July 30, 2024

Re: Design Review for Bridge Square-Riverside Park Improvement Project –
Phase I
Northfield, Dakota and Rice Counties
SHPO Number: 2022-1266

As a result, updated design components presented in 90% design plans include:⁹

SITE
HARDSCAPE
PLAN

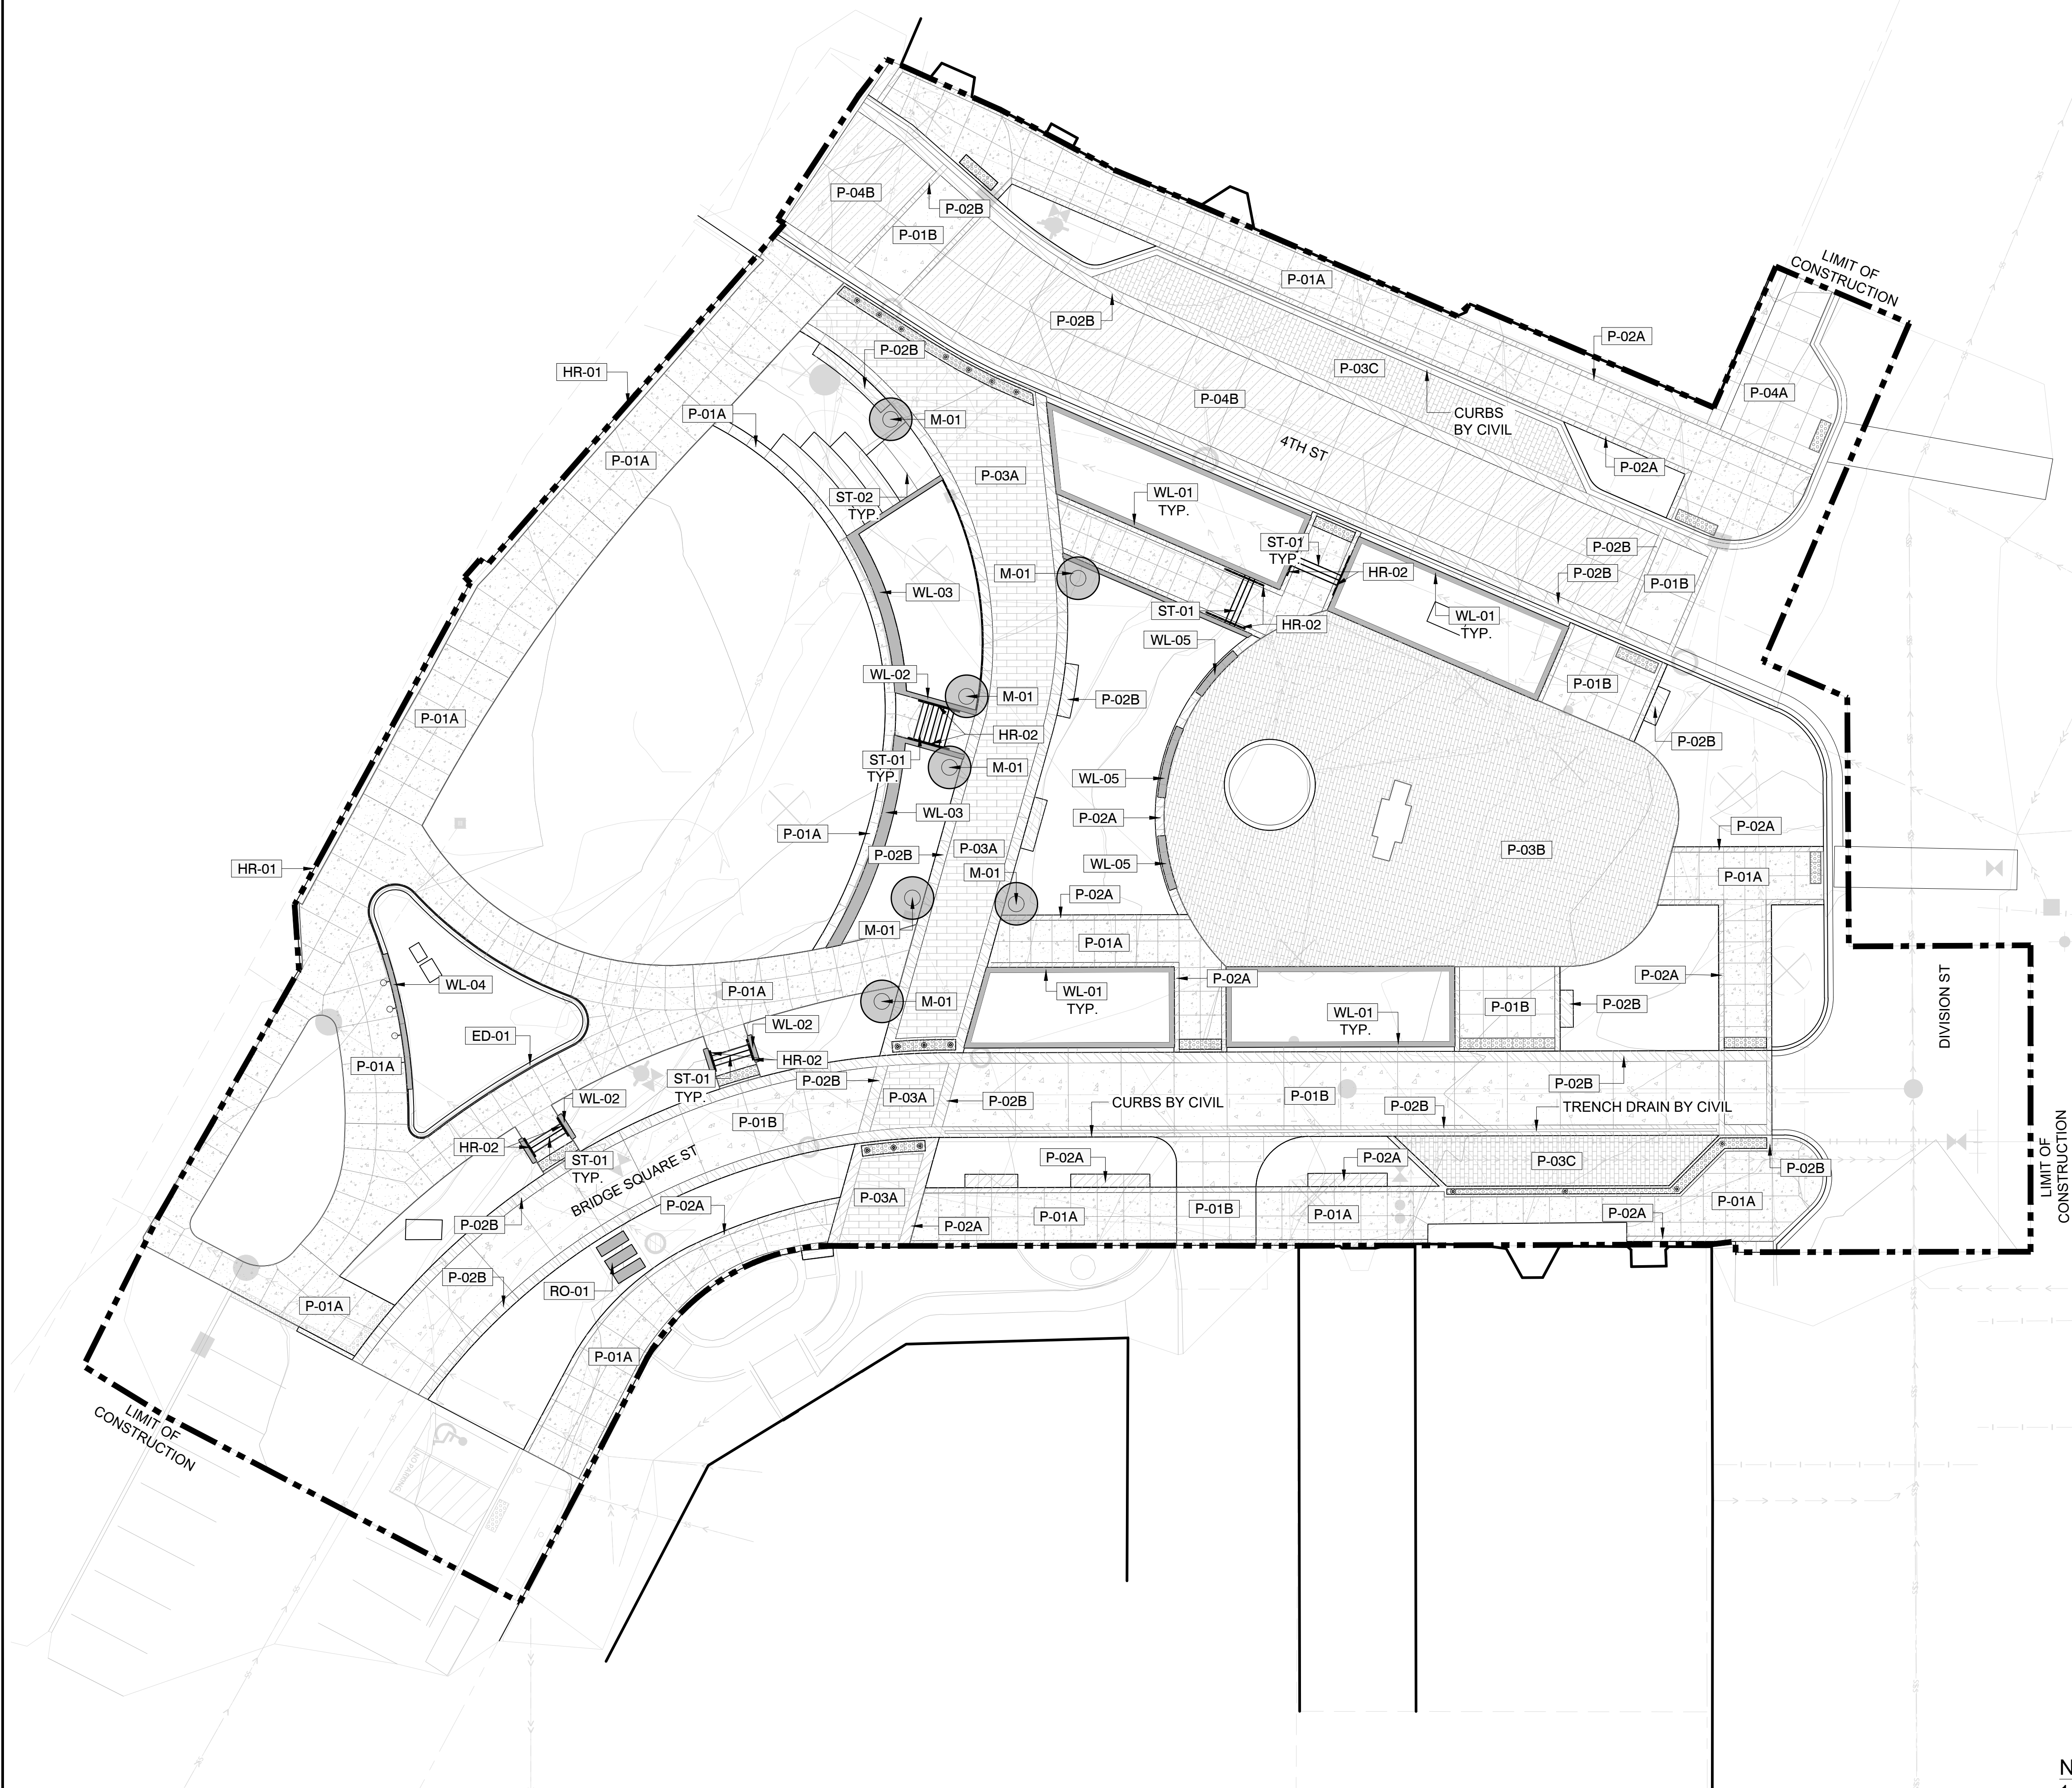
- The addition of two sets of two concrete stairs and handrails at the pedestrian walkway running from 4th Street to the northwest edge of the Bridge Square Plaza to Riverside Park and the Gathering Lawn. The addition of these low-profile stairs at this location ensures that the design maintains the desired, extant slope toward the river. Wheelchair access from 4th Street to Riverside Park and from Riverside Park to Bridge Square Plaza is maintained at other prominent locations.
- Reconfiguring the parking area at the northeast side of 4th Street, to create a total of four parking spaces along 4th Street. Permeable pavers will be installed at this parking area. As part of the ongoing public engagement efforts, local downtown businesses requested more parking; this adjustment addresses that request.

- The consolidation of two parking spaces near the southwest corner of Division Street and Bridge Square Street. Permeable pavers will be installed at this parking area.

- The addition of low, truncated, domed, curbs at a few locations to provide a physical, textural transition at the ground level between the park's edge and the vehicular traffic lanes. These low, domed curbs are proposed to be installed at these locations to increase accessibility, particularly for those with low or no vision. Locations of these low, transitional curbs include several small areas along Bridge Square Street and along the southeast edge of the permeable paver parking section near the southwest corner of Division Street and Bridge Square Street.

- The addition of several precast, curved seat walls adjacent to Bridge Square Plaza, located to the west of the fountain.
- Slightly widening the pedestrian walkway at the edge of Cannon River to provide less congested, easier riverfront access for pedestrians and those using wheelchairs and strollers.

- Slightly changing the shape of two planting beds at the southwest edge of Bridge Square Plaza from two parallelograms to a different parallelogram shape and a rectangle to address issues of constructability at this specific location.

- The addition of three flat, paved steppers in the rain garden, which is located adjacent to the southeast edge of Bridge Square Street, near the southwest perimeter of the park. These steppers will provide pedestrian access through the rain garden to protect the plantings.
